2 March 2016

## NSW Planning Assessment Commission Determination Report

### State Significant Development Application and Modification to Concept Approval Central Park (former Carlton United Breweries Site) (SSD 6376 and MP 06\_0171 MOD 11)

**Figure 2:** Classification of wind conditions/pedestrian comfort levels

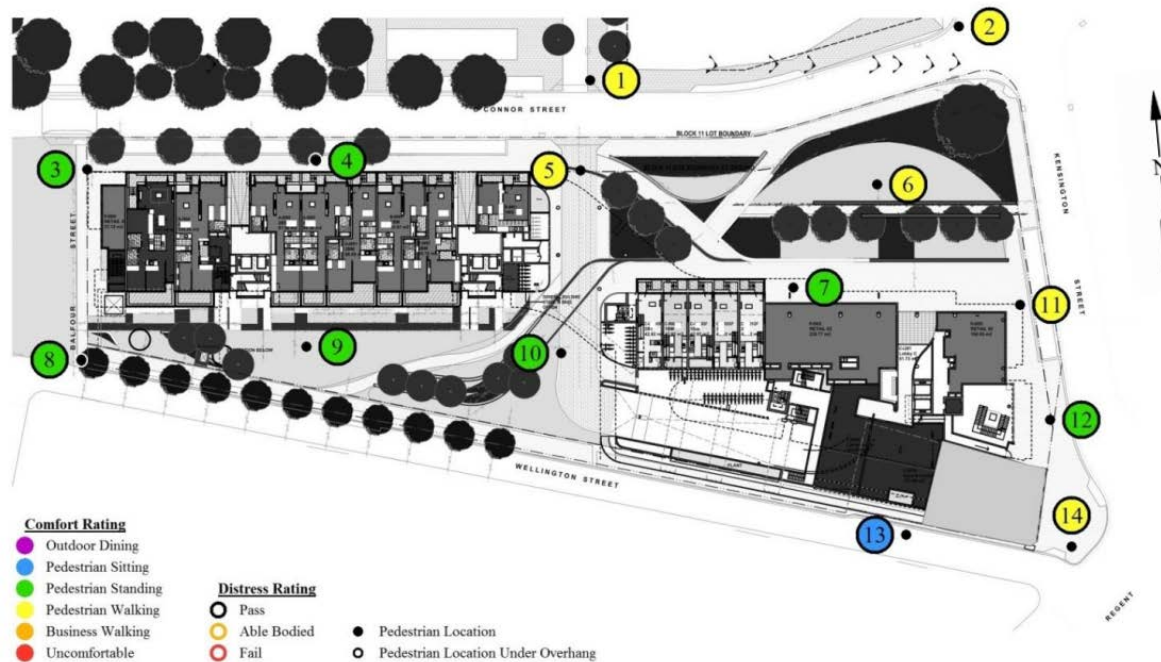
Concerns were raised within various public submissions to the Department regarding potential adverse wind conditions for pedestrians within the site. As part of their application, the Applicant has provided a wind assessment that includes wind modelling for the site. **Figure 2** below demonstrates the predicted wind impacts across the subject site and highlights the level of comfort for each location.

Following the site visit, the Commission requested further clarification on the potential wind impacts on the amenity and use of the proposed open spaces. The Applicant provided further detail about the wind assessment methodology and the measures that could be adopted to reduce potential wind impacts. These measures include additional tree planting, the inclusion of perpendicular fins to the building facades (as appropriate) and planter boxes. The Applicant also noted that the wind impacts for the site are largely governed by Block 9 and were expected to improve with the inclusion of Block 11. The Commission considers that the provision of the open space is critical to the proposal and that the space must be pleasant and usable for the future residents and the community. In response the Commission has applied the following condition to ensure additional measures to reduce the potential impact of wind are implemented.

The Commission notes that the proposed open space area fronting O'Connor Street (location 6) is currently classified as being comfortable for "pedestrian walking". In addition, the area outside the retail units fronting the O'Connor Street park (location 7) is currently classified as being comfortable for "pedestrian standing". However, the Commission is of the opinion that both these open space areas should be enjoyable and provide for "pedestrian sitting" to ensure that it is pleasant and usable for the residents of Central Park and the community. Consequently, the Commission has included the following condition:

**B8** Prior to the issue of any Construction Certificate details are to be provided and approved by the Secretary that demonstrate the measures that have been incorporated within the design in order to reduce the impacts of wind such as;

- Additional large mature trees along O'Connor and Kensington Street;
- External permanent or temporary fins perpendicular to the façade;
- Planter boxes parallel to the façade; and
- Additional trees within park areas.

**B7** Prior to the issue of **any** Construction Certificate, an updated wind assessment shall be submitted for the Secretary's approval. The wind assessment shall demonstrate what additional methods/treatments will be included so as to reduce wind impacts to ensure that the area outside the retail units fronting the O'Connor Street park would be comfortable for pedestrian sitting, and that the O'Connor Street park is comfortable for pedestrian sitting.
